Access Compliance Report

Public Rights-of-Way

Intersection ID: 4693	Main Street: ABBOTSINCH_CT	Cross Street: ARKLOW_RD	Location:	SE
ADA ID: 813407441628	Ramp Type: Perp	Initial Pass/Fail: Fail	Overall Compliance: No	Severity Score: 22.5

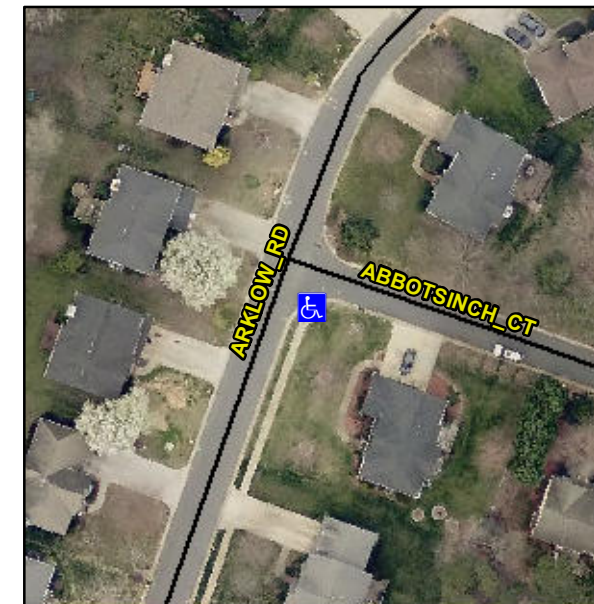
R304.5.1, R304.2.2, R304.5.3

Compliance	Description	Data	Compliance	Description	Data
N/A	Ramp Length (in)	50.0	No	Ramp Slope (%)	8.4
No	Ramp Width (in)	40.0	No	Ramp XSlope (%)	2.8
N/A	Flare Type LT	N/A	N/A	Flare Type RT	N/A
N/A	Flare Slope LT (%)	N/A	N/A	Flare Slope RT (%)	N/A
N/A	Flare Traversable LT?	N/A	N/A	Flare Traversable RT?	N/A
N/A	Landing Length (in)	N/A	N/A	DWS Provided?	N/A
N/A	Landing Width (in)	N/A	N/A	DWS Contrast?	N/A
N/A	Landing Slope (%)	N/A	N/A	DWS Length (in)	N/A
N/A	Landing X Slope (%)	N/A	N/A	DWS Full Width?	N/A
N/A	Landing Curb? (Y/N)	N/A	N/A	DWS Offset (in)	N/A
N/A	Shared Landing?	N/A			
N/A	Gutter Ponding?	N/A	N/A	Gutter Slope (%)	N/A
N/A	Gutter Lip Ht (in)	N/A	N/A	Gutter X Slope (%)	N/A
N/A	Painted X Walk1?	No	N/A	Painted X Walk2?	N/A
	X Walk 1 Direction	To N		X Walk 2 Direction	N/A
N/A	X Walk 1 Width (in)	N/A	N/A	X Walk 2 Width (in)	N/A
	X Walk 1 Slope (%)	0.4		X Walk 2 Slope (%)	N/A
	X Walk 1 X Slope (%)	4.2		X Walk 2 X Slope (%)	N/A

Remove & Replace Entire Ramp.
